CAM115 – MOTOR ASSEMBLY WIRING INSTRUCTIONS

Wiring diagram applies to both OEM and RPI motors that fit
Clay Adams Autocrit I & Micro-Hematocrit I
MOTOR ASSEMBLY

(RPI Part #CAM115 replaces Old RPI Part #CAM049)

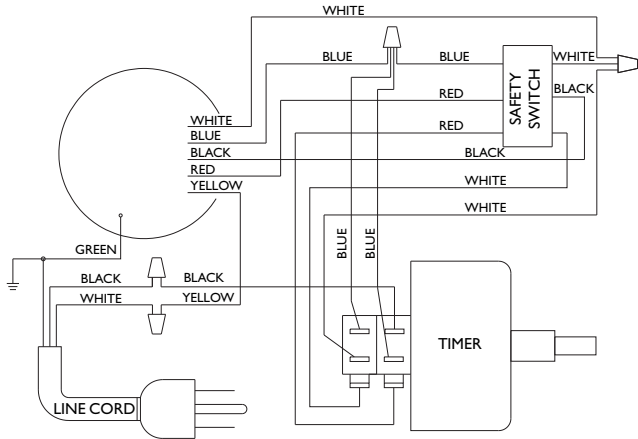
Important Note Regarding Autocrit and Micro-Hematocrit: The head adapter on the old style RPI motors that fit the Autocrit and Micro-Hematocrit can not be removed to allow reuse of the mounting plate. So when replacing the old style RPI Motor Assembly (RPI Part #CAM049) with the new style (RPI Part #CAM115), you will need to replace the round style mounting plate. RPI provides a new round style motor mounting plate free of charge when you order the the new style Motor Assembly (RPI Part #CAM115). See reverse side for details.

WIRE COLOR	GOES TO	TO CONNECTIONS IN CENTRIFUGES
BLACK	GOES TO	S3B COM
RED	GOES TO	S3A COM
BLUE	GOES TO	TB1 NO. 6
YELLOW	GOES TO	TB1 NO. 1
WHITE	GOES TO	S3B N.O. (NORM OPEN)

S3A IS SWITCH CLOSEST TO MOTOR S3B IS SWITCH FURTHEST FROM MOTOR.
